10<sup>th</sup> February 2006

### **Submission to consultation: Management of negative settlement residues in the Snowy Region**

### **RULE CHANGE PROPOSAL / DEROGATION PROPOSAL FOR SNOWY REGION: REVISION OF TRANSMISSION CONNECTION NODES**

**Diagram 1**

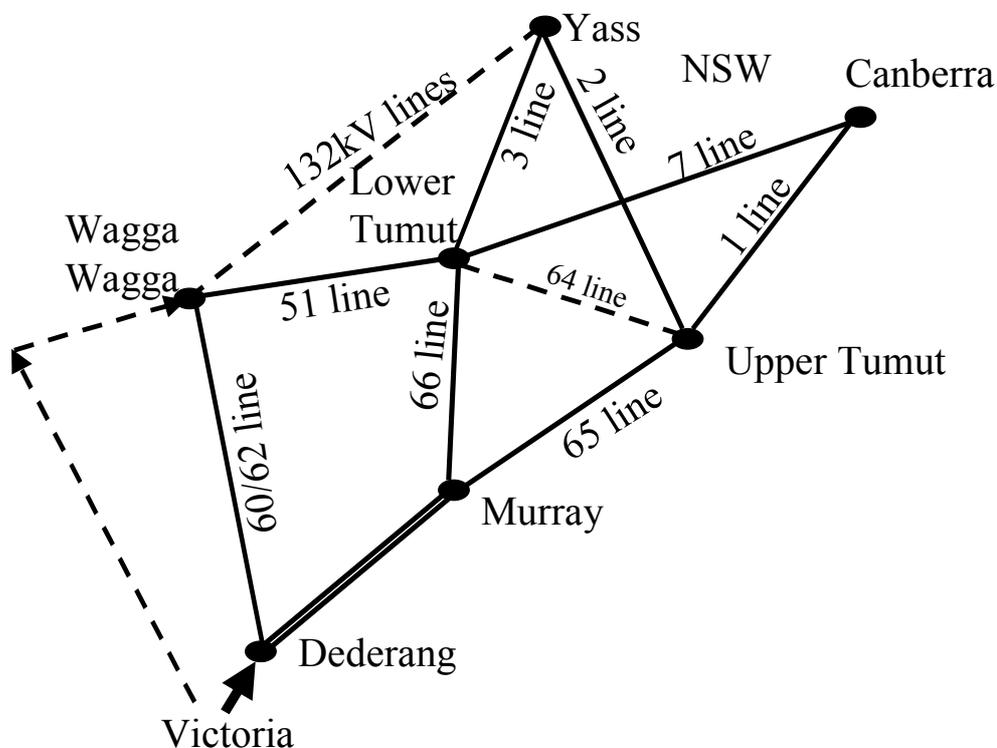
The following diagram 1 presents the network configuration around the Murray node. The loop occurs around the Wagga Wagga load area and additionally includes the West-NSW load (for the northern flow constraint case). Supply from Dederang (via Victoria) due to different impedances distributes 20% more flow through the Wagga Wagga area than in comparison to Murray generation. This is obvious from diagram 1 due to topography of the network.

By taking a more holistic view of the market and the interactions between generators located in different pricing regions it can be demonstrated that the LYMMCO Rule proposal is narrow in focus and does not consider wider competition issues associated with the Snowy Region. In particular,

- It only looks narrowly at Murray pricing and does not address other inter-related problematic issues. Snowy Hydro highlights that the constraints on the 81/82 lines from the western NSW and Hunter Valley group of generators “western ring generators” places incentives on these generators to bid at very low prices (down to -\$1000) and still be immune to their very low local price (since they receive the Sydney West (NSW) price). These incentives place Tumut generation in a situation where it needs to withhold generation capacity to align the TUMUT price with the NSW price to hedge contractual exposure to the NSW node. In these situations, Tumut generation is essentially pay-as-bid, while ‘western ring’ generators are paid the NSW common clearing price. This is an inefficient outcome as explained in APPENDIX 2.

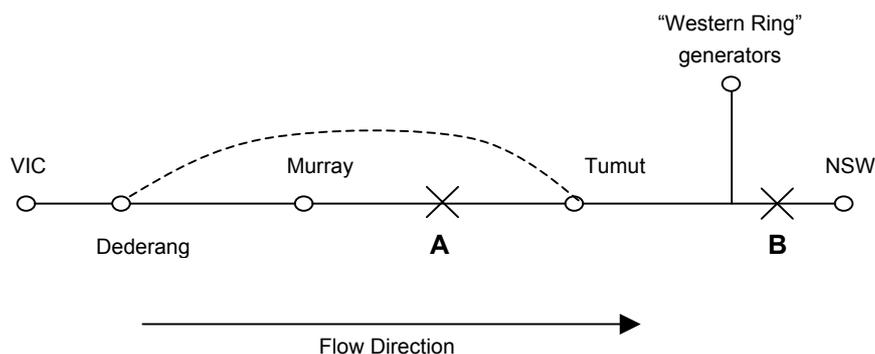
- When a constraint occurs between Murray and Tumut with a northerly flow, the market uses the following constraint equation:

- Vic price = 0.8 Snowy price + 0.2 NSW price

but in reality:

- Vic price = 0.8 Murray price + 0.2 **Lower Tumut** price.

That is, with Lower Tumut generation forced to re-price capacity from the market, the Tumut local price is held artificially high. This means that the Victorian price is artificially high with the end result being inefficient since Victorian customers pay an artificially high price for their energy. While it is clear that this perversely benefits the Victorian generators, it also clearly creates a market inefficiency and dis-benefits Victorian/SA customers. It is emphasised that the western ring generators are oblivious to bidding low at their local node because they receive the high Sydney West price but in fact bid down to -\$1000.
